APPLICATION NO.	FILING DATE	FIRST NAMED INVENTOR	ATTORNEY DOCKET NO.	CONFIRMATION NO.
10/595,841	05/15/2006	Warren Thomas Johnson	2003P87067WOUS	7643
28524 SIEMENS COF	7590 03/30/201 RPORATION	EXAMINER		
INTELLECTUAL PROPERTY DEPARTMENT			ANDERSON, DENISE R	
170 WOOD AVENUE SOUTH ISELIN, NJ 08830			ART UNIT	PAPER NUMBER
			1778	
			MAIL DATE	DELIVERY MODE
			03/30/2011	PAPER

Application No.	Applicant(s)	Applicant(s)		
Office Action Summary		10/595,841	JOHNSON, WAR	JOHNSON, WARREN THOMAS		
		Examiner	Art Unit			
		Denise R. Anderson	1774			
Perio	The MAILING DATE of this communication app d for Reply	pears on the cover sheet with	the correspondence a	ddress		
V	SHORTENED STATUTORY PERIOD FOR REPLY (HICHEVER IS LONGER, FROM THE MAILING DAE Extensions of time may be available under the provisions of 37 CFR 1.13 after SIX (6) MONTHS from the mailing date of this communication. If NO period for reply is specified above, the maximum statutory period we failure to reply within the set or extended period for reply will, by statute, Any reply received by the Office later than three months after the mailing earned patent term adjustment. See 37 CFR 1.704(b).	ATE OF THIS COMMUNICA 36(a). In

Specification, Fig. 1, Membrane Module Compared to Cote et al. Membrane Module in Figs, 9, 9A, & 9C

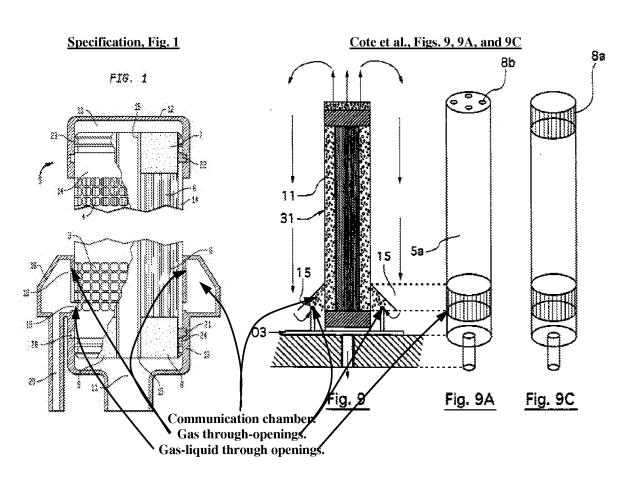
7. The second embodiment shown in Fig. 9 is an example of applicant's recited "aeration/backwash device [that] is adapted to at least partially surround a portion of said membrane module" and "gas is supplied . . . through said through-openings in a direction substantially perpendicular to a longitudinal axis of said membranes to provide cross flow gas distribution for aerating the membranes." Cote et al., col. 12, lines 4-12. This Cote et al. embodiment of the aeration/backwash device is shown below, along-side of applicant's claimed structure.

8. In the Fig. 9 embodiment of the aeration/backwash device, Cote et al. discloses small through-openings shown at the ends of the ozone supply means 15 and large through-openings shown as lower open-worked zone 8. Cote et al., Fig. 9. Referring to Figs. 9, 9a, 9b, and 9c, Cote et al. further teaches that the gas is supplied through the small through-openings "by pipes positioned essentially perpendicularly to the longitudinal axis of the modules (applicant's membrane modules)." Cote et al., col. 12, lines 4-12. This meets the functional limitation that gas is supplied through "the through-openings in a direction substantially perpendicular to a longitudinal axis of said membranes to provide a substantially even cross flow gas distribution for aerating the membranes within the membrane module."

Specification, Fig. 1, Membrane Module Compared to Cote et al. Membrane Module in Figs, 9, 9A, & 9C

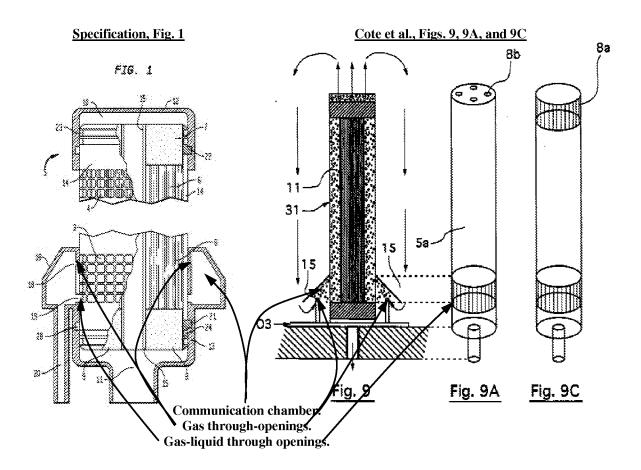
(see Fig. 9). It can be clearly seen that the upstanding pipes in Cote et al. are oriented in a position parallel to the fiber bundles (see Fig. 9). The ozone emitted by the pipes initially travels in a direction parallel to the longitudinal axis of the modules and is then guided towards the fiber bundles by an angled hood. In this arrangement, the gas is not directed in an orientation which is perpendicular to the fiber bundles. Therefore, the arrangement in Cote does not provide cross flow gas distribution relative to the fibers as in the current invention. In addition, Cote cannot provide a substantially even gas distribution because its through-holes in the lower open worked zone 8 are elongated, eliminating the possibility of an even cross flow of gas." Applicant's Remarks, p. 10, lines 12-22. Applicant makes a similar argument regarding claim 11.

In the Fig. 9 embodiment of the aeration/backwash device, Cote et al. discloses small through-openings shown at the ends of the ozone supply means 15 and large through-openings shown as lower open-worked zone 8. Referring to Figs. 9, 9a, 9b, and 9c, Cote et al. further teaches that the gas is supplied through the small through-openings "by pipes positioned essentially

perpendicularly to the longitudinal axis of the modules (applicant's membrane modules)." Cote et al., col. 12, lines 4-12. As such, Cote et al. meets the functional limitation that gas is supplied through "the <u>through-openings</u> in a direction substantially perpendicular to a longitudinal axis of said <u>membranes</u> to provide a substantially even cross flow gas distribution for aerating the <u>membranes</u> within the <u>membrane module</u>."

39. The examiner responds as in the above patentability analysis. Applicant's claimed invention is shown alongside of the prior art.
